CAMY 4kV O/O BELVEDERE SUB

PROPOSED CONSTRUCTION (LOCATION)
424 RECORD AVE
EAST LOS ANGELES

SHEET ___ OF ___ JOB NO. 490366_0.01

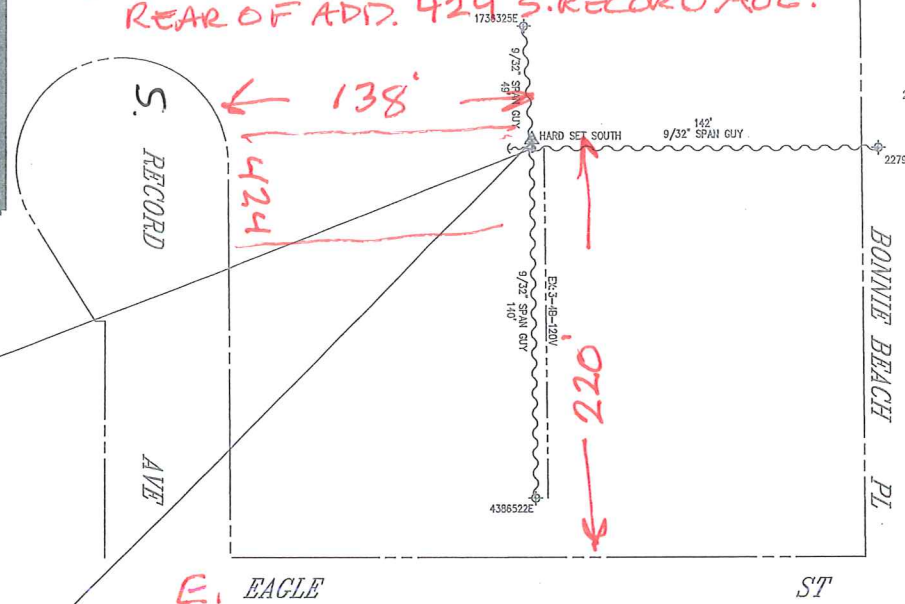
FIM IS WRONG 2279085E IS 90° FROM 7405E
6B SL LOOKS IDLE PLEASE VERIFY
REAR PROPERTY LINE POLE
